Access Compliance Report

Public Rights-of-Way

(Curb Ramps)

Intersection ID: 42736	Main Street: CONNELL_GREEN_DR	Cross Street: CALDWELL_FOREST_DR	Location: S
ADA ID: 080D669D1504	Ramp Type: PerpDiag	Initial Pass/Fail: Fail	Overall Compliance: No
Severity Score: 8.75			
Codes/Mitigation Info/Possible Solution		Field Measurements/Component Compliance

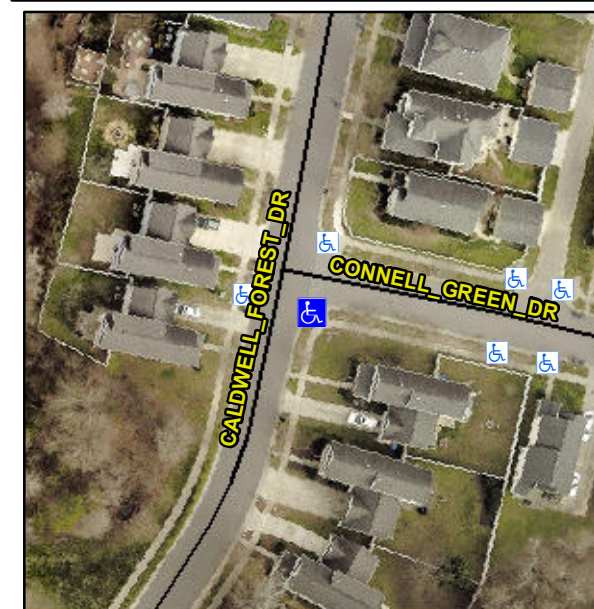
Not Found, R304.5.1

Compliance	Description	Data	Compliance	Description	Data
N/A	Ramp Length (in)	58.5	Yes	Ramp Slope (%)	6.3
No	Ramp Width (in)	42.5	Yes	Ramp XSlope (%)	1.8
N/A	Flare Type LT	N/A	N/A	Flare Type RT	N/A
N/A	Flare Slope LT (%)	N/A	N/A	Flare Slope RT (%)	N/A
N/A	Flare Traversable LT?	N/A	N/A	Flare Traversable RT?	N/A
N/A	Landing Length (in)	N/A	N/A	DWS Provided?	N/A
N/A	Landing Width (in)	N/A	N/A	DWS Contrast?	N/A
N/A	Landing Slope (%)	N/A	N/A	DWS Length (in)	N/A
N/A	Landing X Slope (%)	N/A	N/A	DWS Full Width?	N/A
N/A	Landing Curb? (Y/N)	N/A	N/A	DWS Offset (in)	N/A
N/A	Shared Landing?	N/A			
N/A	Gutter Ponding?	N/A	N/A	Gutter Slope (%)	N/A
N/A	Gutter Lip Ht (in)	N/A	N/A	Gutter X Slope (%)	N/A
N/A	Painted X Walk1?	No	N/A	Painted X Walk2?	No
	X Walk 1 Direction	To N		X Walk 2 Direction	To W
N/A	X Walk 1 Width (in)	N/A	N/A	X Walk 2 Width (in)	N/A
	X Walk 1 Slope (%)	3.1		X Walk 2 Slope (%)	2.3
	X Walk 1 X Slope (%)	0.3		X Walk 2 X Slope (%)	2.2

N/A	Ramp inside XWalk1?	N/A	N/A	Ramp inside XWalk2?	N/A
	Road Slope (%)	1.6	N/A	Clear Space?	N/A
	Road X Slope (%)	3.2	N/A	Clear Space to XWalk (in)	N/A
N/A	Any Obstructions?	N/A	N/A	Storm Grate/Utility Hazard?	N/A
	Obstruction Type			Storm Grate/Utility Type	
		N/A			N/A
			Yes	Surface Condition? (G/P)	Good

Remove & Replace Curb Ramp With Two New Directional Ramps or Equivalent.
